SAFETY RECOMMENDATION

A. N. S. V.

Prot. USCITA
N.0005115/11
Data 25/08/2011

Subject: accident occurred on Trieste-Ronchi dei Legionari airport (LIPQ) to the Diamond DA42 “TwinStar” registration marks S5-DNE, on April 11th, 2010.

Figure 1: Main Landing Gear Dumper Scheme.

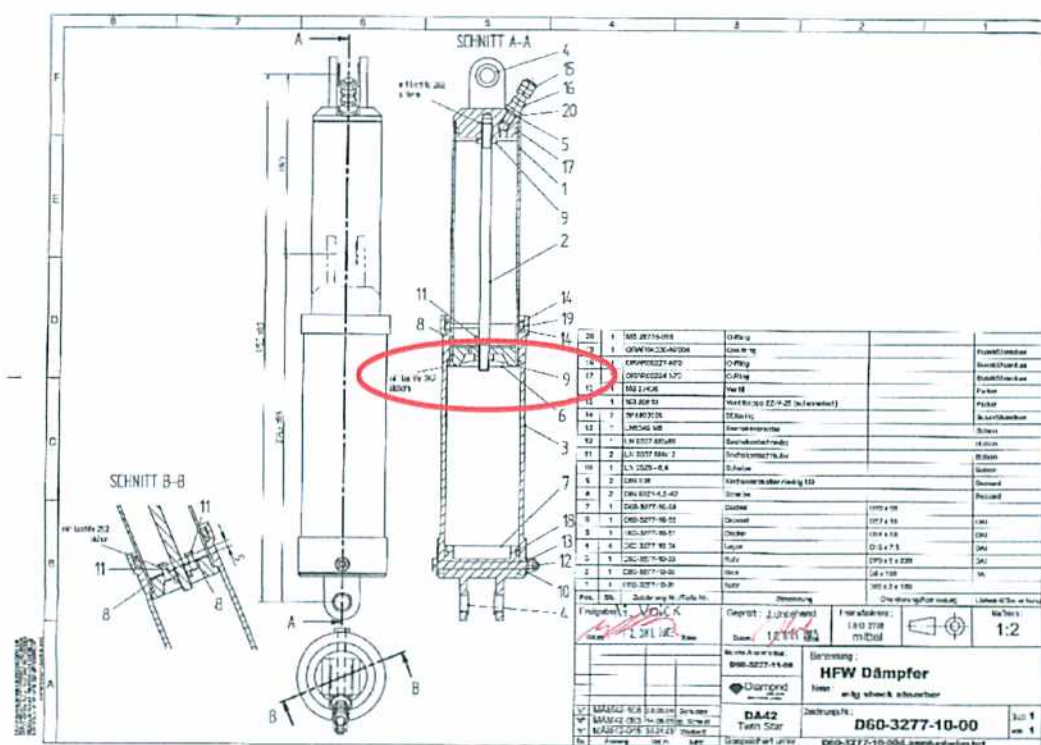
The microscope analysis showed the presence of “red residual” on the threads of item “2” in the position of item “9”.

The analysis have demonstrated that the Loctite 262 had been applied on the item “9” but we cannot be sure if it has been tightened as prescribed by the AMM.

The event was due to the unscrew of the nut (item “9” on figure 1) that made the shock absorber longer than the project requirements.

The investigation and the analysis performed demonstrates that the method chosen by Designer to lock the item “9” on the figure 1 appears to be not adequate. In addition it is not possible to inspect it without the removal and disassembly of the whole shock absorber.

- an additional inspection should be asked as soon as possible to the Operators/Owner of the aircraft now in operation, in order to check the component for the installation of the item “9” - figure 1, on all dumpers not yet modified as per RSB 42-089/1 (ANSV-14/351-10/1/A/11);
- the different choice on the nut locking method stated on the RSB 42-089/1 should become “mandatory” since the previous solution adopted by Designer (application of Loctite 262 only) appears to be not sufficient at all (ANSV-15/351-10/2/A/11).
